NUMBER 014

Fiat 1.6 petrol engines / Synchronous Drive / Tensioner Info.

GATES REFERENCE:	5432XS and related kits.	
MAKE:	FIAT / LANCIA.	
MODEL:	Albea, Brava, Bravo, Dedra, Delta, Doblò, Lybra, Marea, Multipla, Palio, Siena, Stilo, Strada.	
MOTOR:	1.6 petrol.	
MOTOR CODE:	178B3000, 178C7098, 178D2011, 182A4000, 182A6000, 182B5098, 182B6000, 182B6000CNG, 182B6024, 185A3000, 186A3000CNG, 186A4000.

Fig. 4

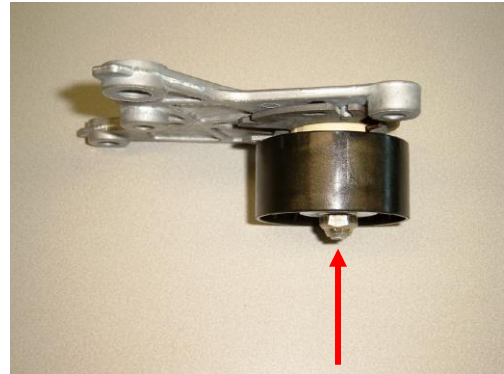
It may be possible that the tensioner on the car is still an older model. There is no problem to install the latest version tensioner with the old stud and nut. Although the depth of the fixing hole (A) of the tensioner is deeper and the stud stays the same, there is still enough room on the stud to fix the nut properly, see Fig. 5 (B).

Fig. 4 and Fig. 5 show the latest version of the tensioner fixed on the bracket.

Normally this bracket (C) is mounted on the engine block and does not have to be removed.

Fig. 6

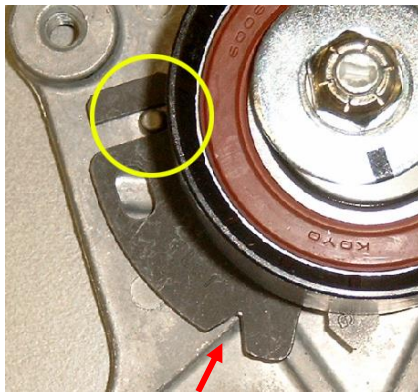
To lock the tensioner, position the open oblong hole in the base plate of the tensioner on the pin on the bracket (Fig. 6).

Fig. 7

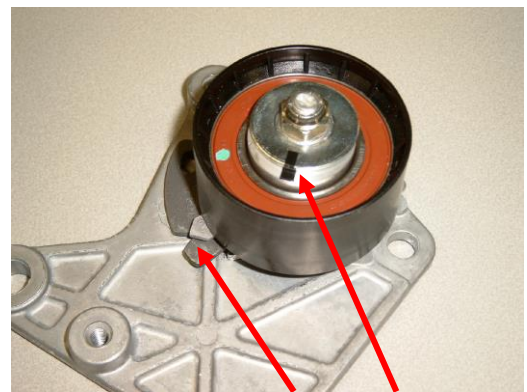
When the belt and the tensioner are replaced, following the installation instructions inserted in the kit, and after two engine revolutions, the pointer (D) has to be in the middle of the "V" in the base plate of the tensioner (E). At that moment the two black marks (F) will also be aligned. Only then the tensioner is correctly installed.

Fig. 8

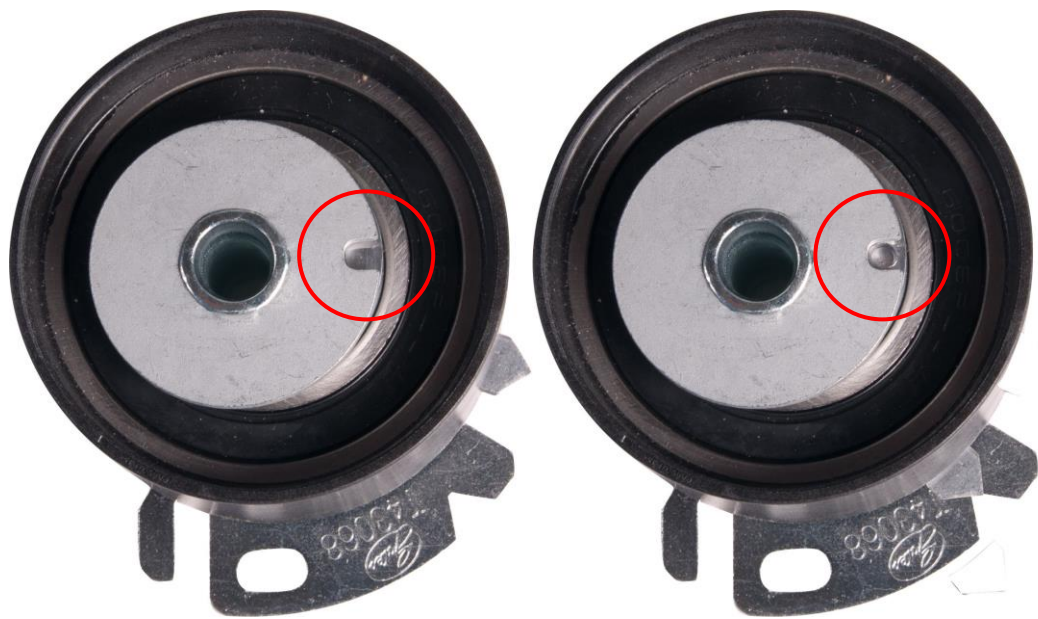
In the actual kits you find the tensioner (Fig. 8) on which we have changed the black marks into a new positioning system. The indicator of the correct position is a point in relief.

Not in the correct position:

In the correct position:
